**RESPONSE TO SUBMISSIONS  
State Significant Development SSD-5746**

**Proposed Expansion of Existing Mainfreight Facility  
including Storage of Dangerous Goods (Chemical Storage Facility)**

**30-50 Yarrowa St, Prestons  
(Lots 101 & 102 DP 1117691 and Lot 2 DP 28729)**

**July 2013**

REVISED DRAWING TX-03

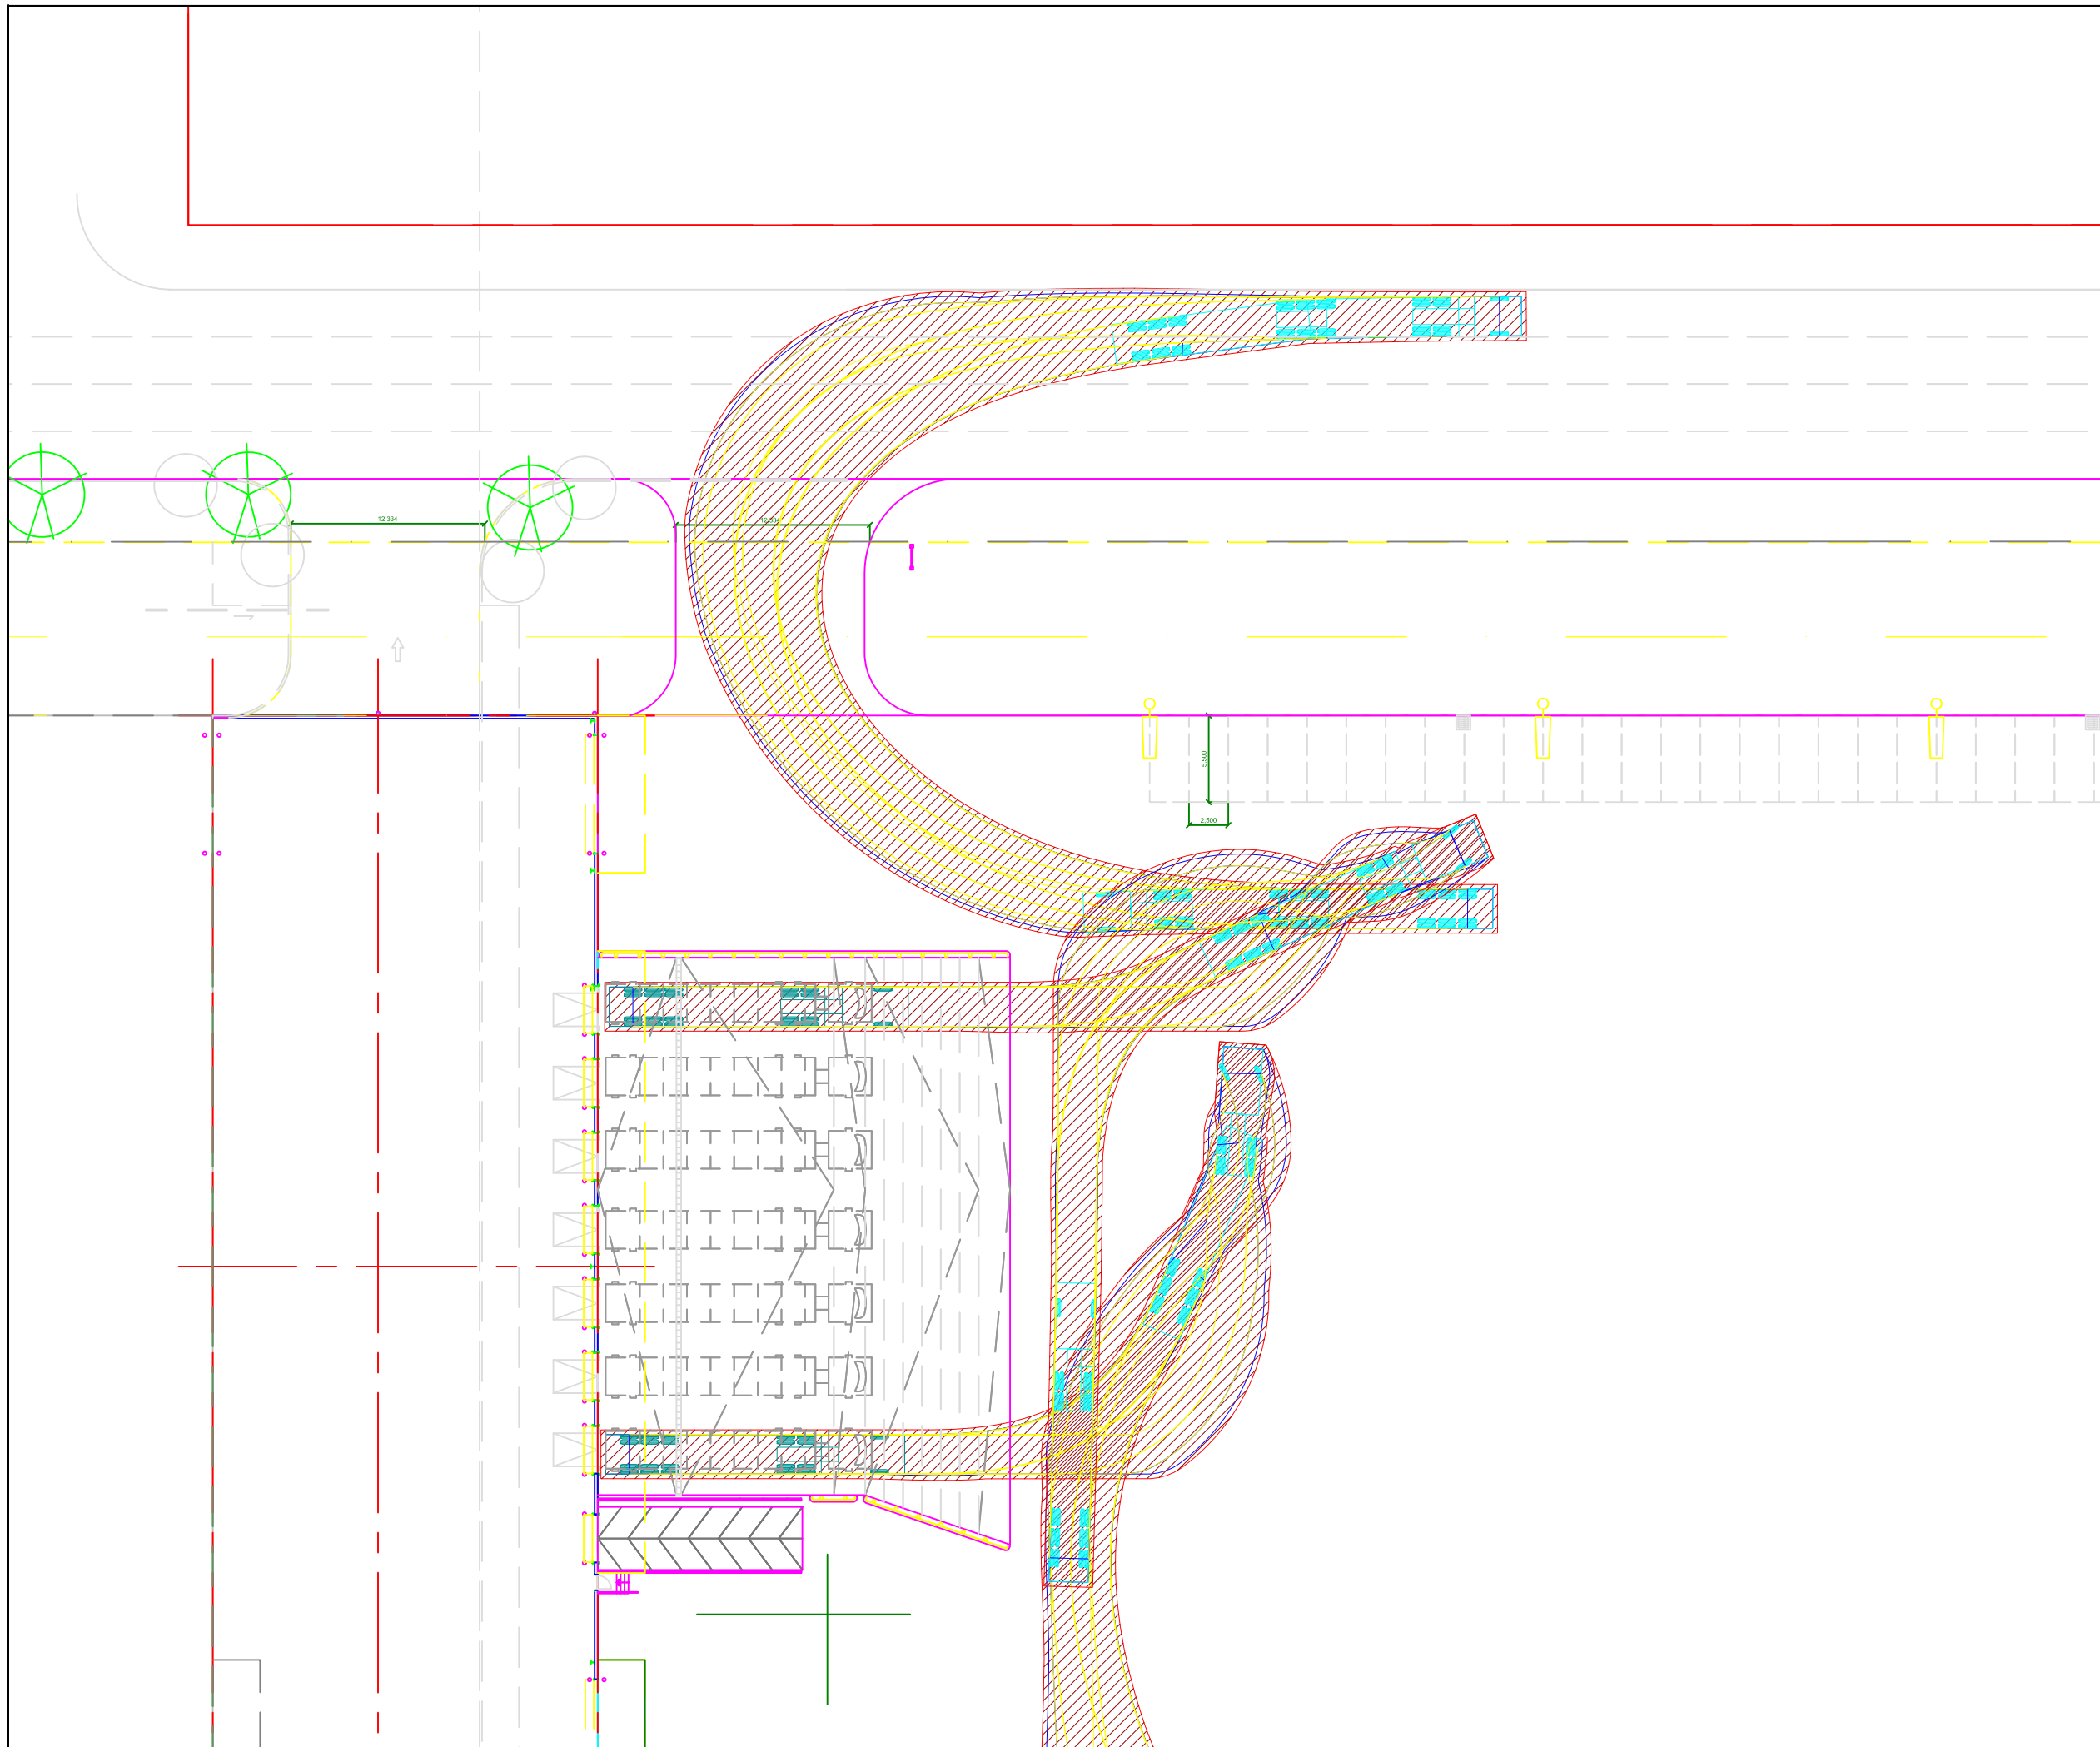
| Summary of Submission – Item 1                                     | Swept Path Drawing No. TX.03 appears to show a truck exiting the site using the existing driveway which is proposed to be located and reinstated.  |
| Summary of Submission – Item 2                                     | Swept Path Drawing No. TX.03 shows trucks exiting the site only, while the architectural plans show this as a combined truck entry/exit point. Truck movements through this access point needs to be clarified, especially in light of the commitment given that no dangerous goods will transported through the TransGrid easement. |

| Response   | Drawing TX.03 is being updated to remove the swept path that is erroneously shown on the left hand side of the plan. A revised plan is provided as <b>Appendix 4</b> .   |
| Response   | The plan will remain as indicated on the architectural plan as it is expected the latest round of consultation with TransGrid will remove the restriction of prohibiting trucks carrying dangerous goods within the easement.  |
